Origination Form
Proposed Revisions to a Standard Plans Index

Originator:	Turley, Joshua	Index Number:	700-091
Date:	4/23/2025	Sheet Number(s):	Sheet 2
E-mail:	Joshua.Turley@dot.state.fl.us	Index Title:	CATWALK DETAILS

GENERAL ASSEMBLY AND FIXED BASE DETAILS

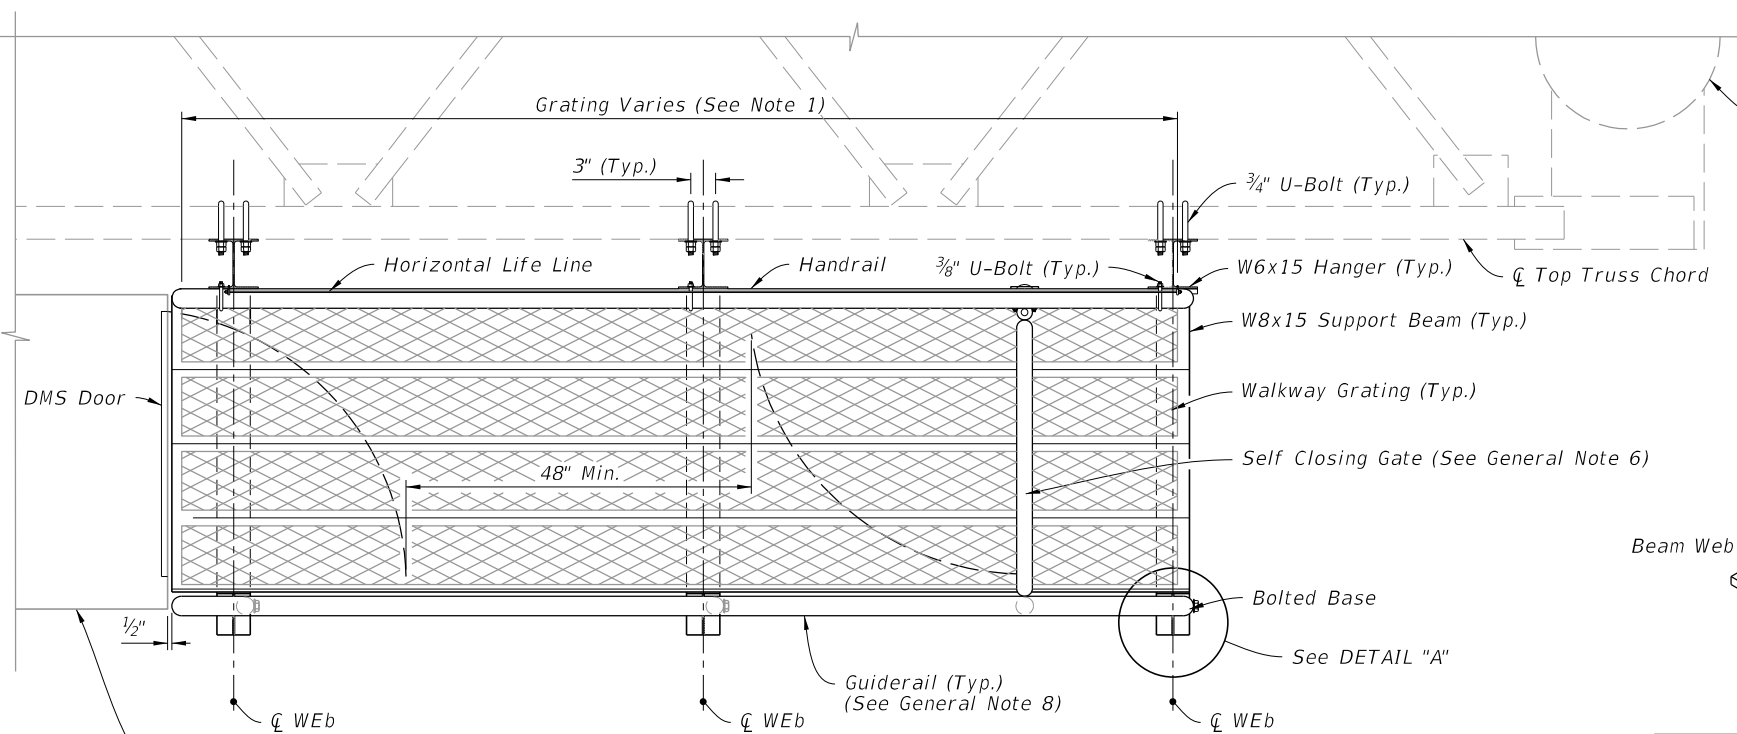
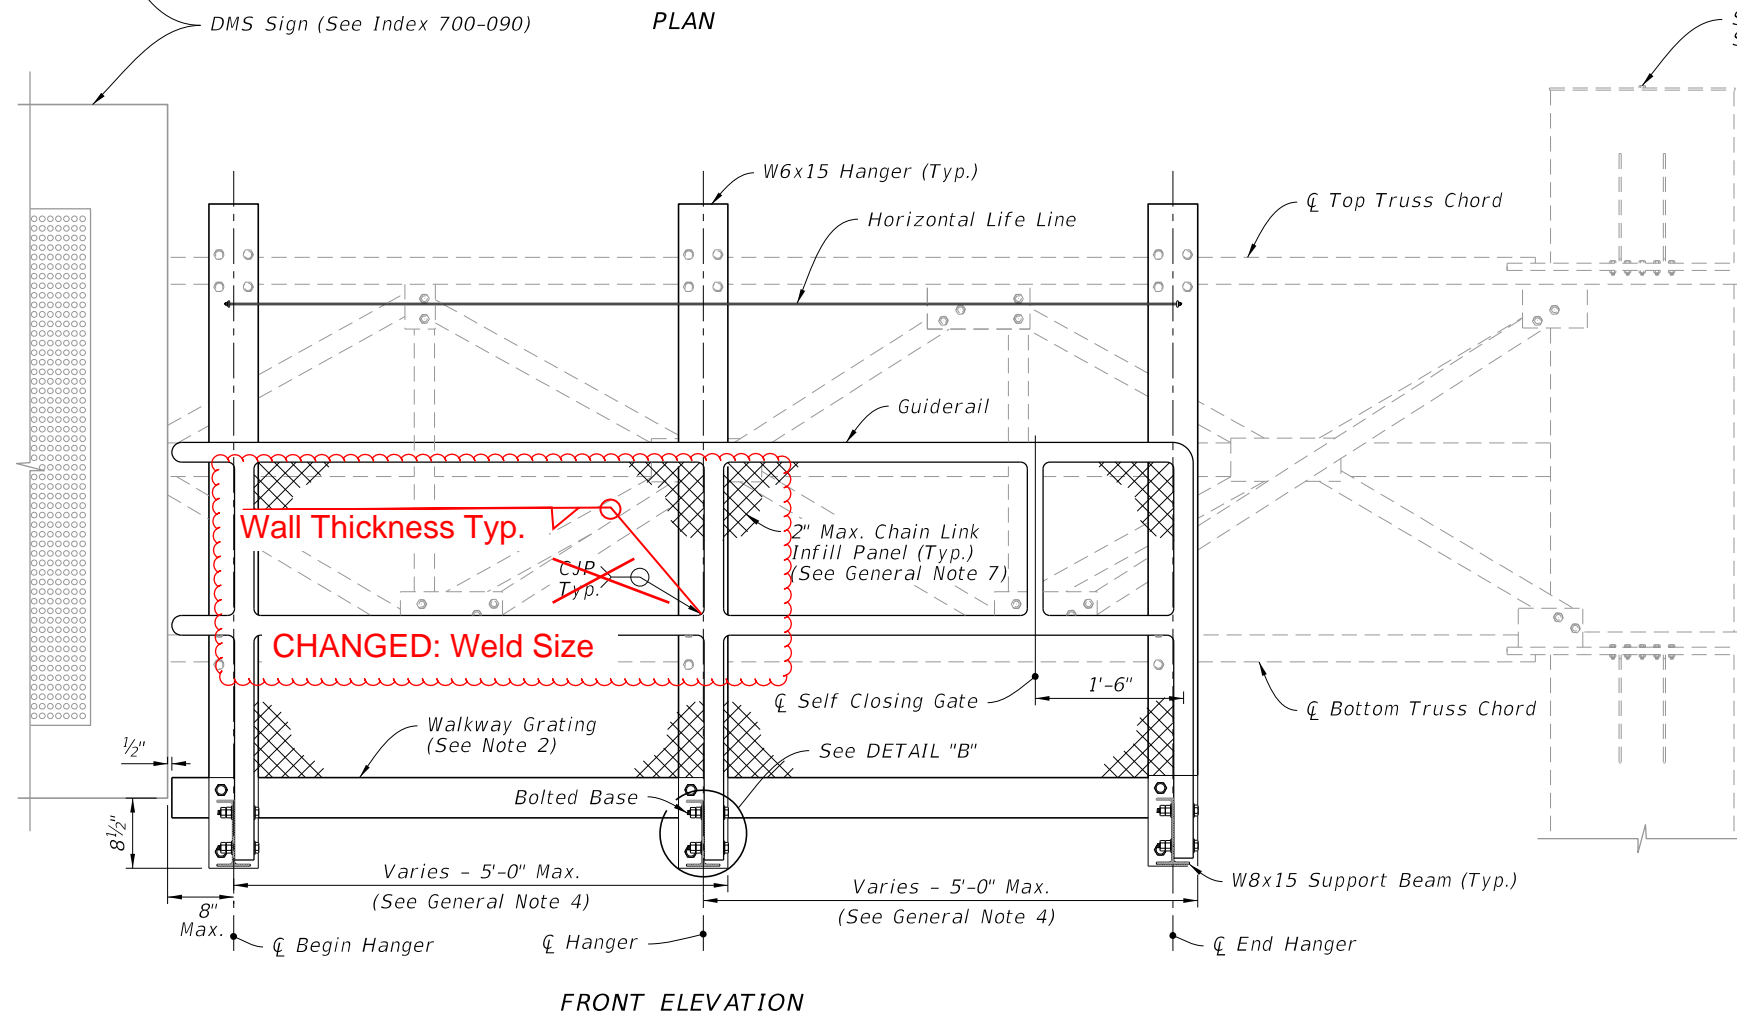
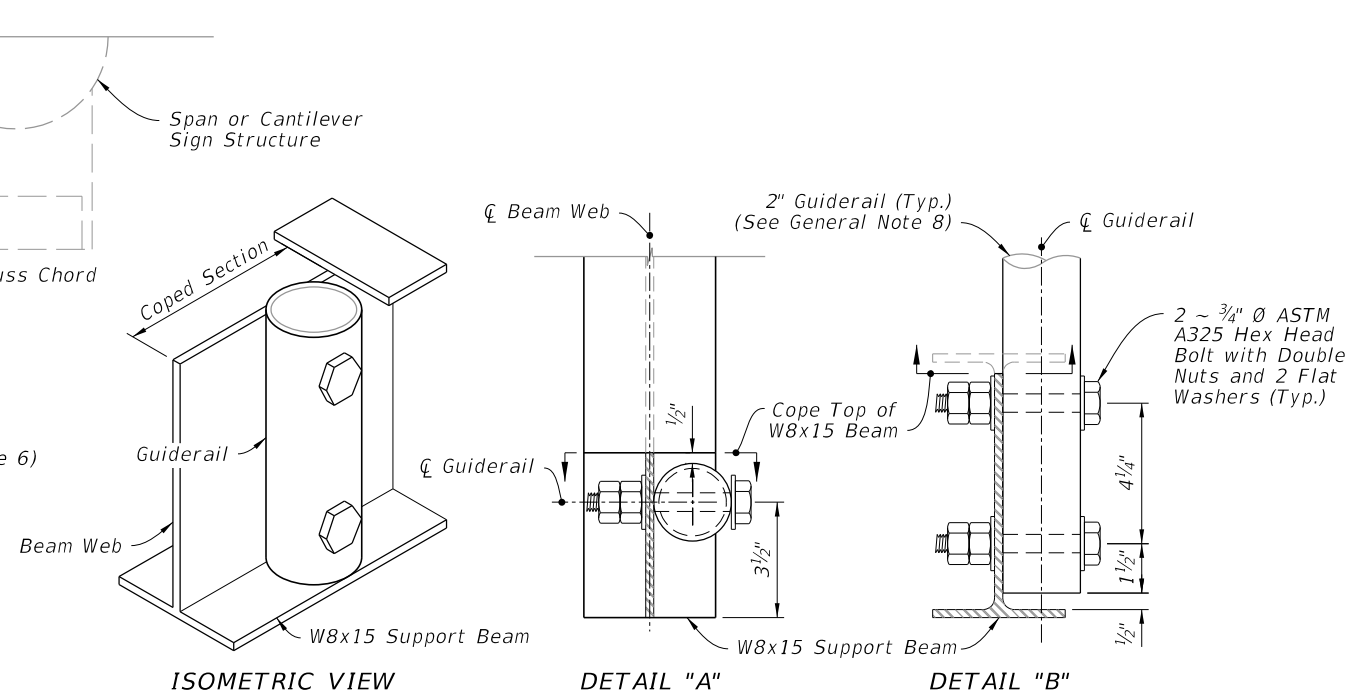
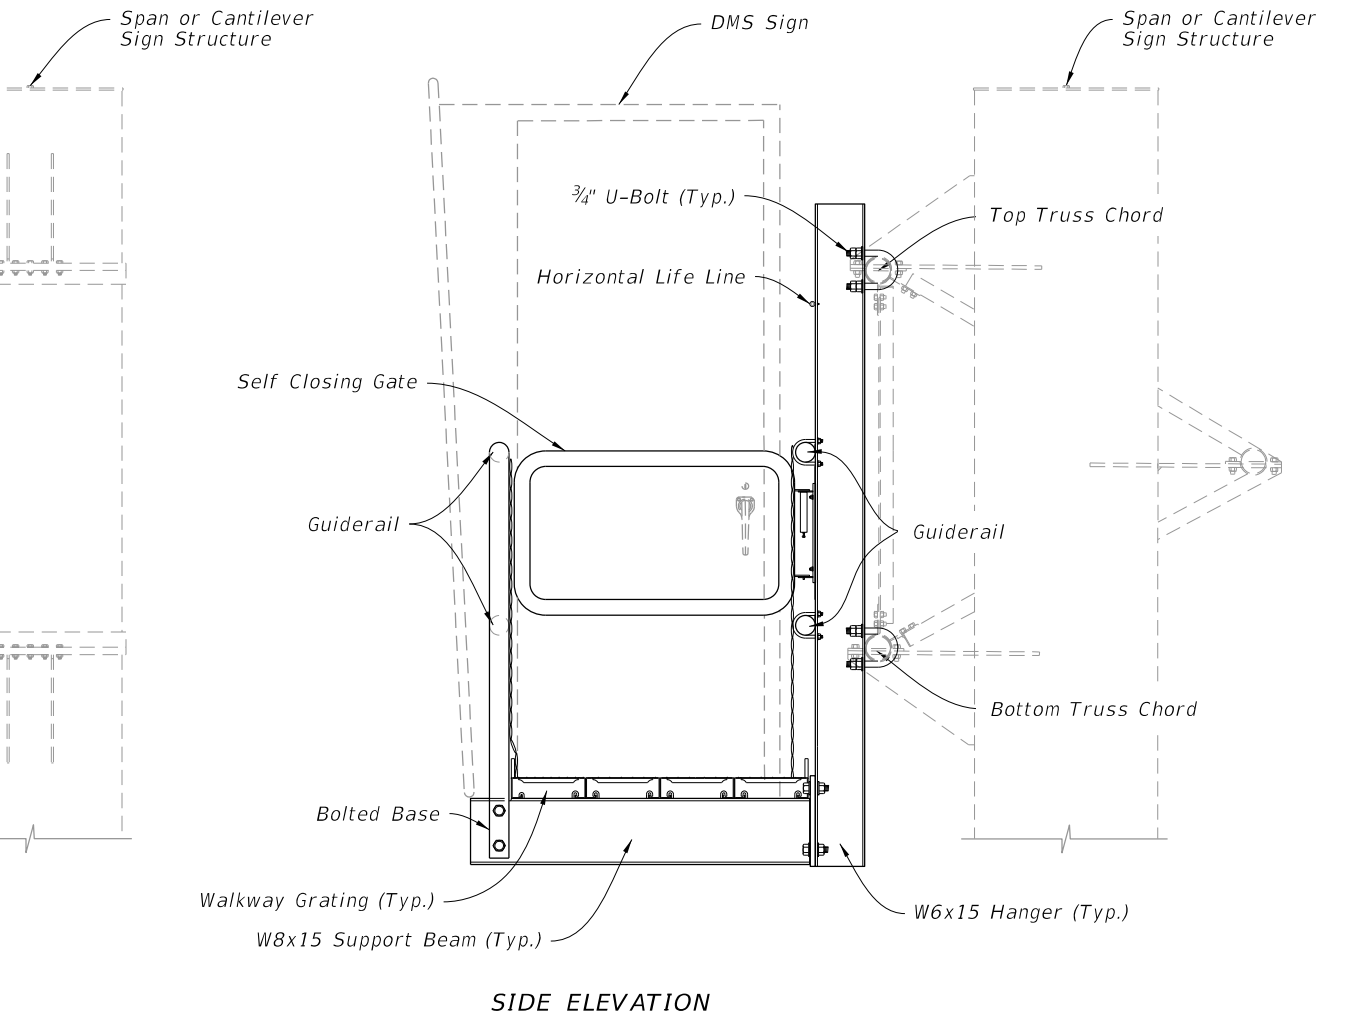
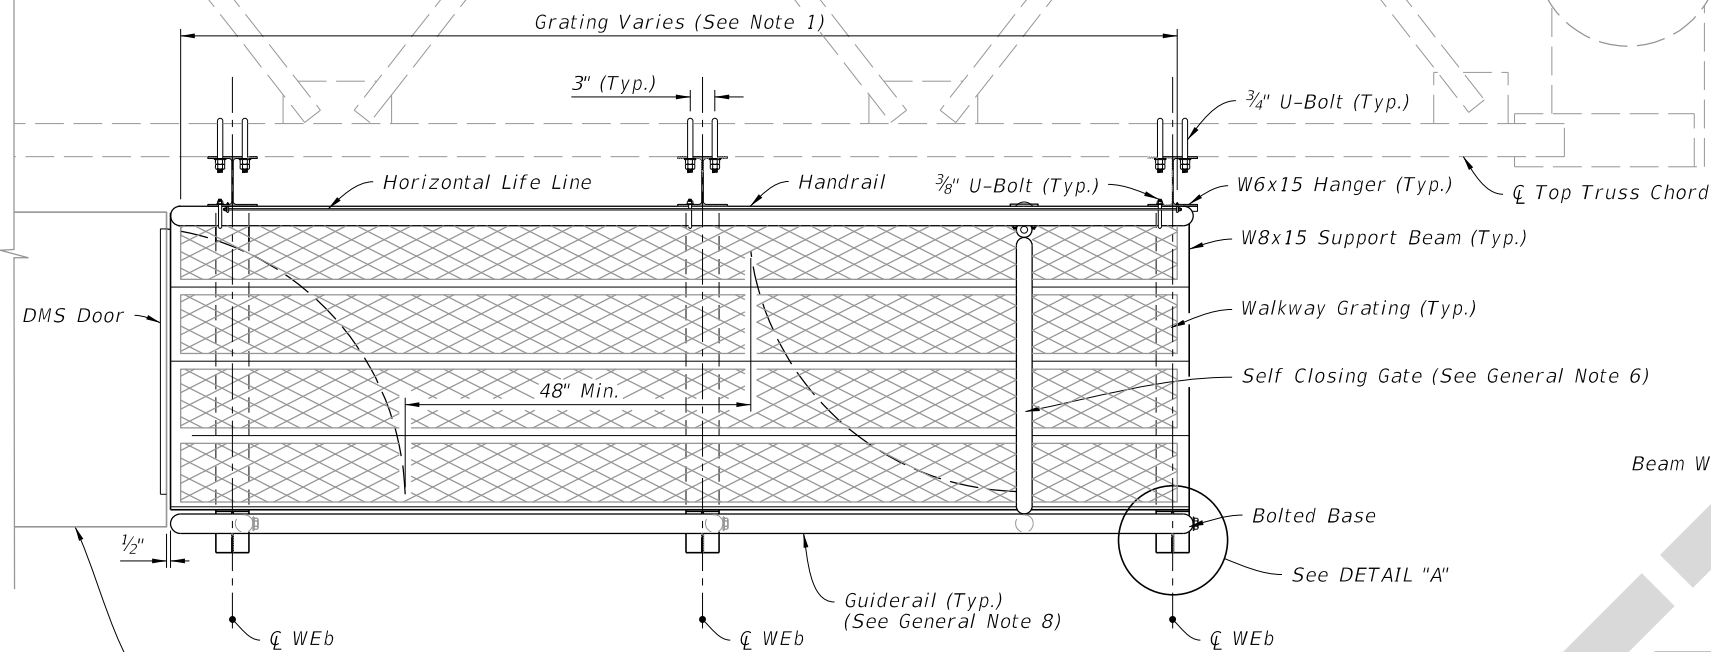
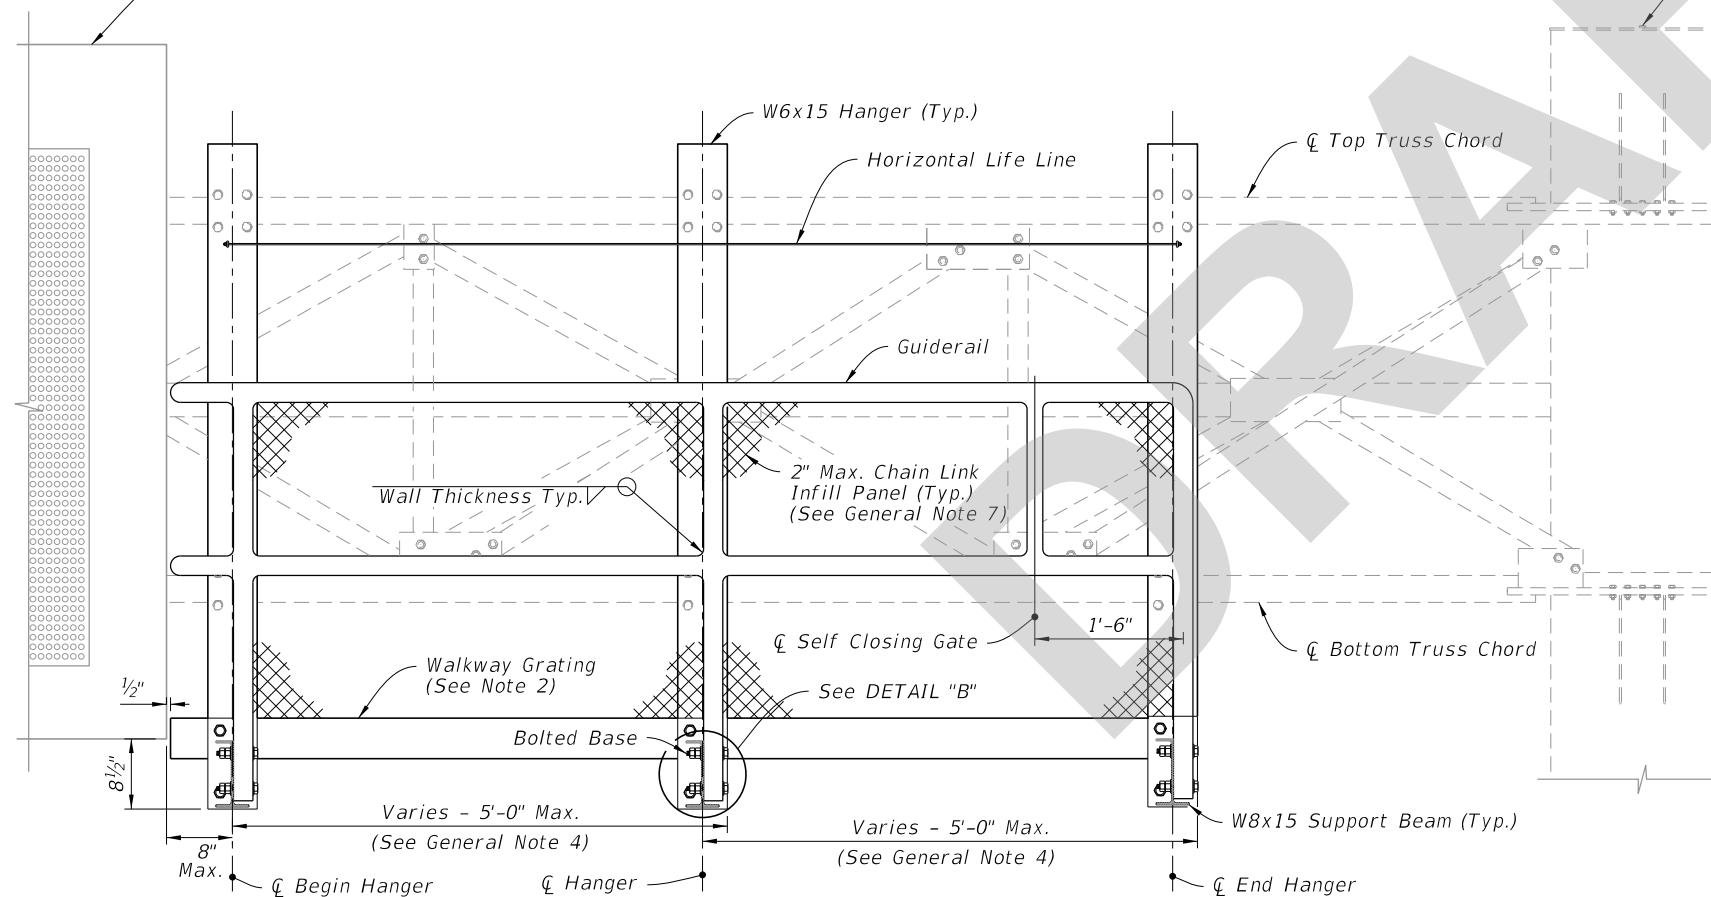
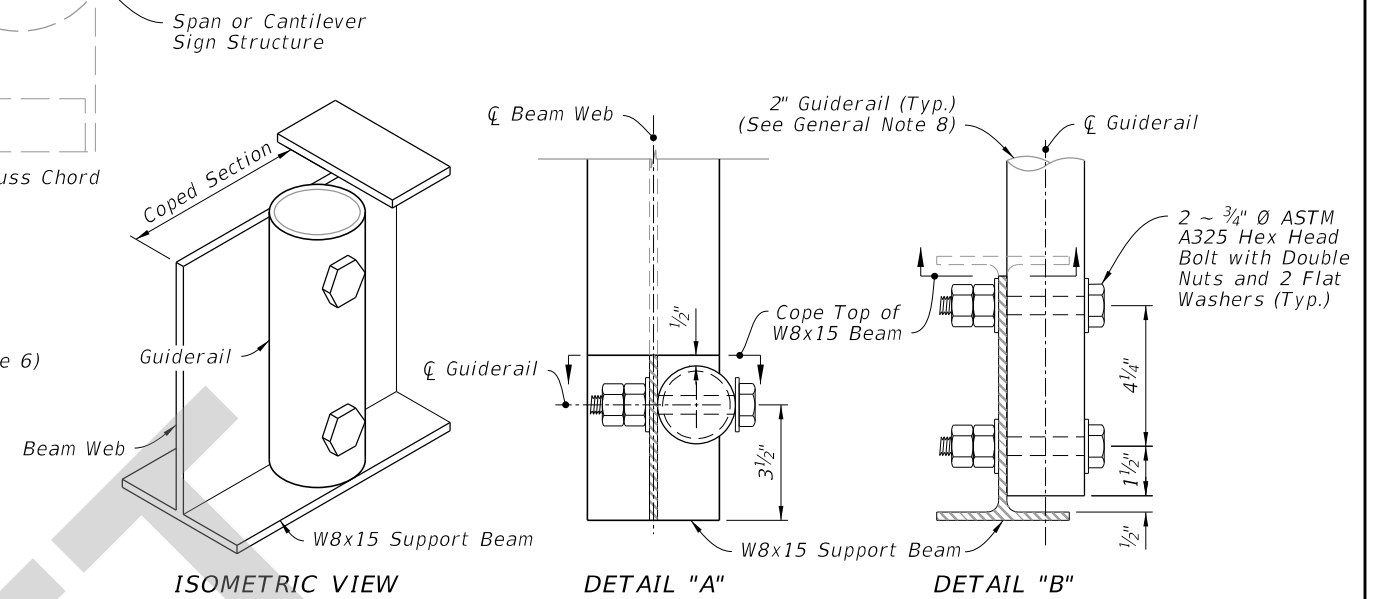
Sheet 2: Changed the weld size for the tube to tube connections of the guardrail.

The original weld size was overly conservative and not cost-effective. After analysis, the Structures Office specified a more appropriate weld for this index.
